E/ECE/324
E/ECE/TRANS/505 } Add.7/Rev.3/Amend.2

Addendum 7: Regulation No. 8

Revision 3 - Amendment 2

UNIFORM PROVISIONS CONCERNING THE APPROVAL OF MOTOR VEHICLE HEADLAMPS EMITTING AN ASYMMETRICAL PASSING BEAM OR A DRIVING BEAM OR BOTH AND EQUIPPED WITH HALOGEN FILAMENT LAMPS (H_1, H_2, H_3, HB_3, HB_4, H_7 and/or H_8)

Figure 1

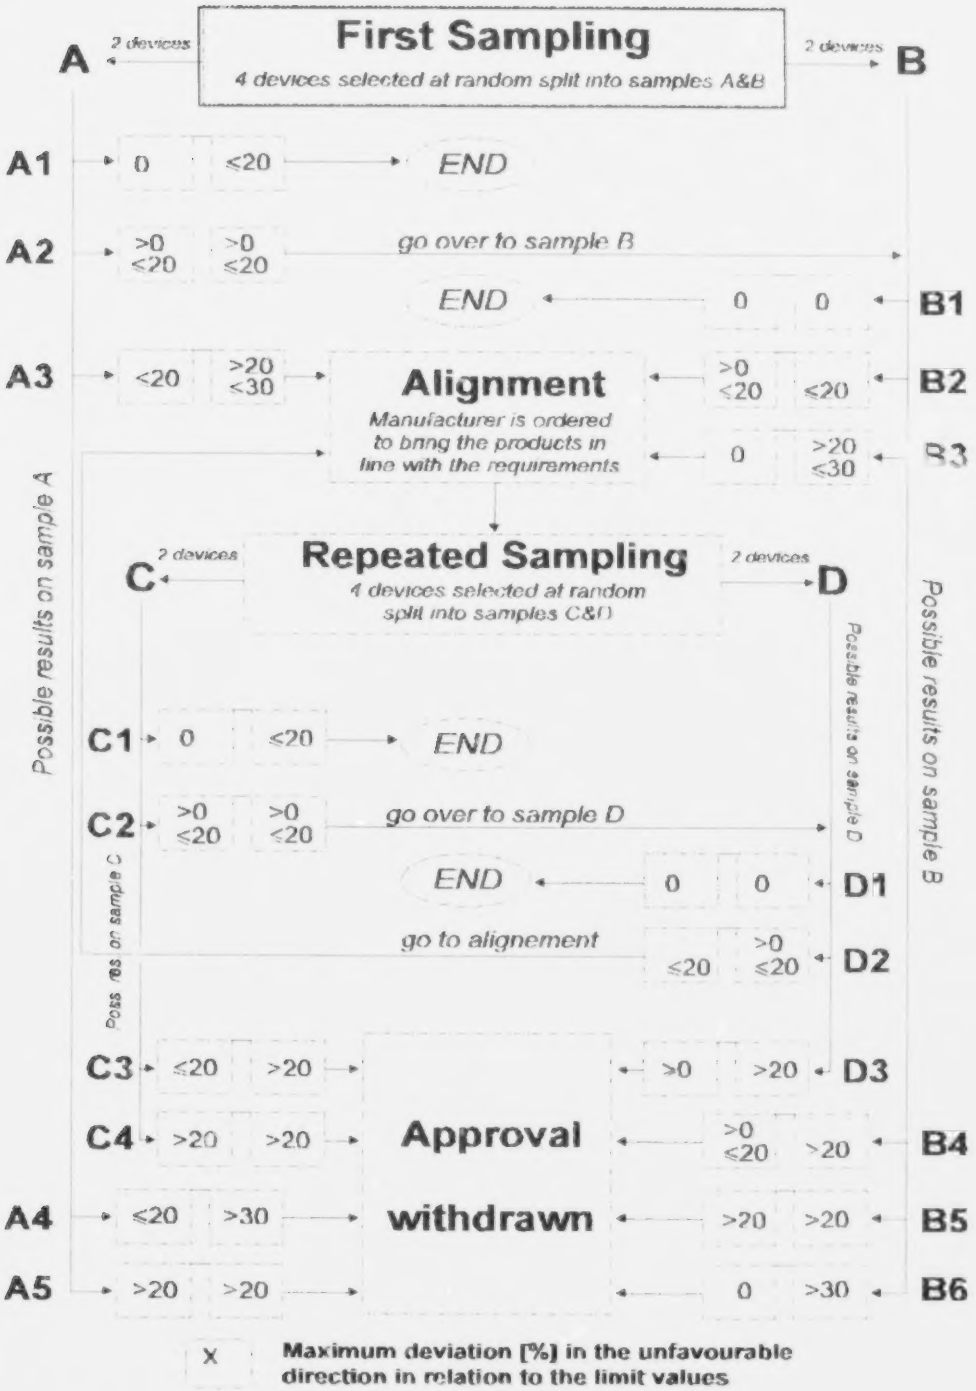
Add a new Annex 7, to read:

In the first sampling four headlamps are selected at random. The first sample of two is marked A, the second sample of two is marked B.

2.1.1. Following the sampling procedure shown in Figure 1 of this annex the conformity of mass-produced headlamps shall not be contested if the deviation of the measured values of the headlamps in the unfavourable directions are:

2.2.1. Following the sampling procedure shown in Figure 1 of this annex the conformity of mass-produced headlamps shall be contested and the manufacturer requested to make his production meet the requirements (alignment) if the deviations of the measured values of the headlamps are:

Conformity shall be contested and paragraph 13 applied if, following the sampling procedure in Figure 1 of this annex, the deviations of the measured values of the headlamps are:

In the cases of A3, B2, B3 a repeated sampling, third sample C of two headlamps and fourth sample D of two headlamps, selected from stock manufactured after alignment, is necessary within two months time after the notification.
